## Aberfeldy Estate

London Thames Gateway Development Corporation

planning application no.PA/11/02716

### Strategic planning application stage 1 referral (new powers)

Figure 2 masterplan layout and building heights (source: design and access statement)

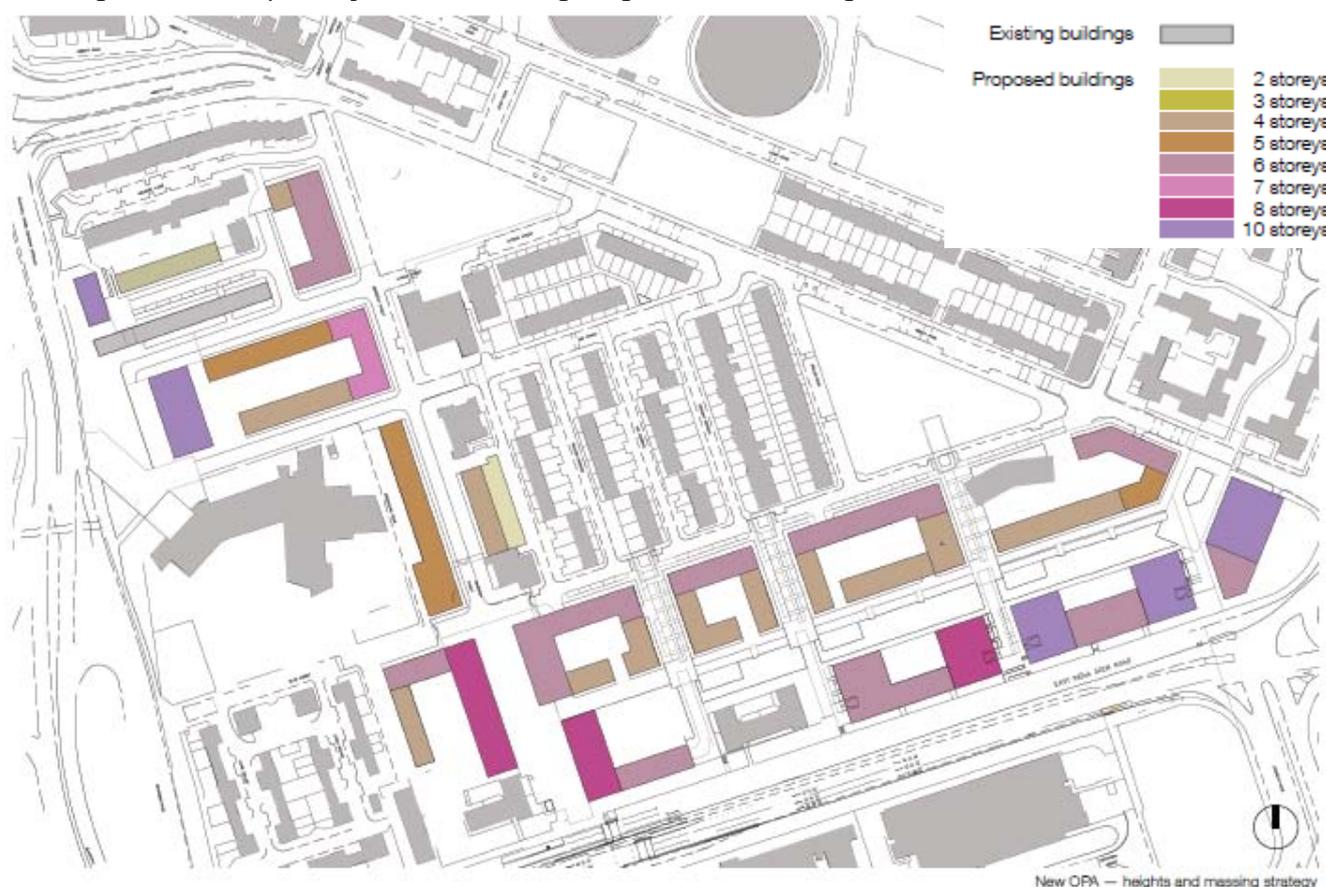
41 The average density has been calculated by the applicant to be 376 habitable rooms per hectare. Figure 4 and 5 above also reflect the density per phase and the change from the original application. The applicant should provide further analysis on the distribution of density having regard to the guidance in the plan. The northern part of the site has low accessibility and some of the highest densities proposed. A breakdown of where this occurs and the justification in policy terms needs to be clearly articulated. Some of this work has been undertaken as set out in page 34 of the design and access statement. In some instances density above the guidance in the London Plan may be acceptable subject to other objectives in the plan including design quality, provision of affordable family housing, sustainability and other criteria. The scheme goes some way to meet the policy objectives in terms of estate renewal and will deliver a high proportion of family housing. Further work is however required to secure the principles of design quality as discussed further below.

Figure 4 consultation zones (source: design and access statement)

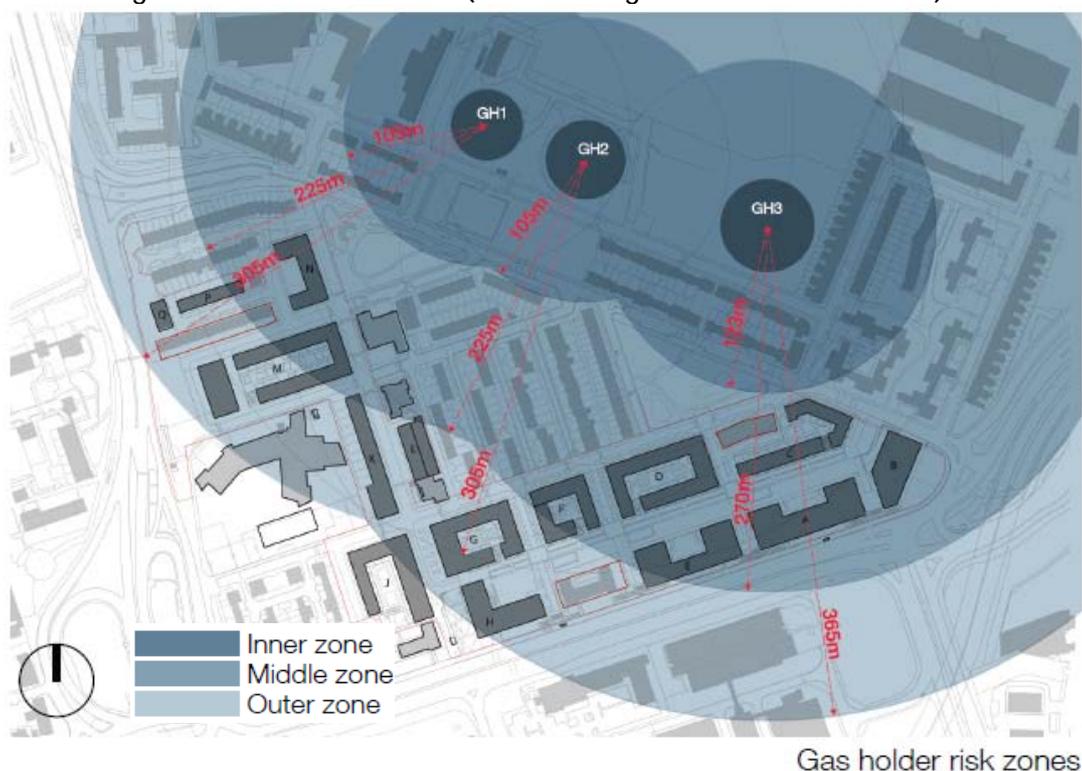
27 The advice from the HSE is currently unknown, however given the densities proposed that fall within the middle consultation zone the application is likely to receive an advise against recommendation. It is understood that the Corporation is in the process of procuring independent advice regarding the merits of the applicant's revised Risk Assessment. GLA officers therefore require further discussion with all relevant parties regarding the extent to which the societal risk and other risks have now been considered. It is important that the HSE form part of these ongoing discussions.
